# Access Compliance Report

## Public Rights-of-Way

### (Curb Ramps)

Intersection ID: 19324	Main Street: OLD_GATE_DR	Cross Street: OLD_HOUSE_CR	Location: NW
ADA ID: E3F7478F7708	Ramp Type: PerpDiag	Initial Pass/Fail: Fail	Overall Compliance: No
Severity Score: 21.25			
Codes/Mitigation Info/Possible Solution		Field Measurements/Component Compliance

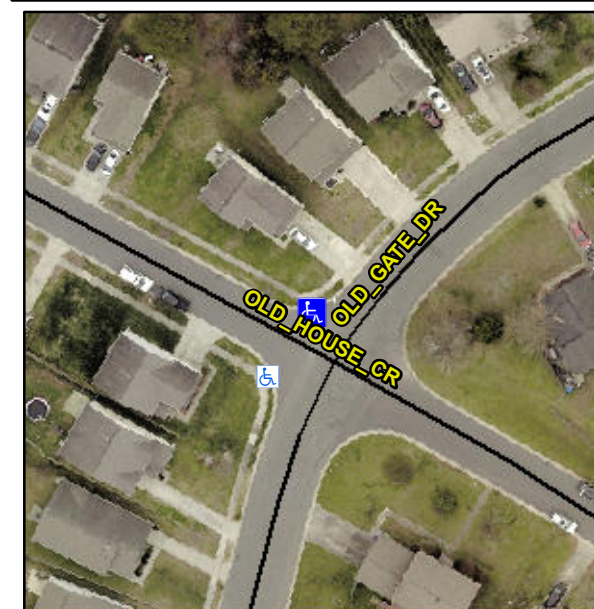
**Not Found, R304.5.1, R304.5.3**

Compliance	Description	Data	Compliance	Description	Data
N/A	Ramp Length (in)	81.0	Yes	Ramp Slope (%)	7.6
No	Ramp Width (in)	47.0	No	Ramp XSlope (%)	5.2
N/A	Flare Type LT	N/A	N/A	Flare Type RT	N/A
N/A	Flare Slope LT (%)	N/A	N/A	Flare Slope RT (%)	N/A
N/A	Flare Traversable LT?	N/A	N/A	Flare Traversable RT?	N/A
N/A	Landing Length (in)	N/A	N/A	DWS Provided?	N/A
N/A	Landing Width (in)	N/A	N/A	DWS Contrast?	N/A
N/A	Landing Slope (%)	N/A	N/A	DWS Length (in)	N/A
N/A	Landing X Slope (%)	N/A	N/A	DWS Full Width?	N/A
N/A	Landing Curb? (Y/N)	N/A	N/A	DWS Offset (in)	N/A
N/A	Shared Landing?	N/A			
N/A	Gutter Ponding?	N/A	N/A	Gutter Slope (%)	N/A
N/A	Gutter Lip Ht (in)	N/A	N/A	Gutter X Slope (%)	N/A
N/A	Painted X Walk1?	No	N/A	Painted X Walk2?	No
	X Walk 1 Direction	To SW		X Walk 2 Direction	To SE
N/A	X Walk 1 Width (in)	N/A	N/A	X Walk 2 Width (in)	N/A
	X Walk 1 Slope (%)	1.1		X Walk 2 Slope (%)	2.8
	X Walk 1 X Slope (%)	2.3		X Walk 2 X Slope (%)	0.8

**Remove & Replace Curb Ramp With Two New Directional Ramps or Equivalent.**
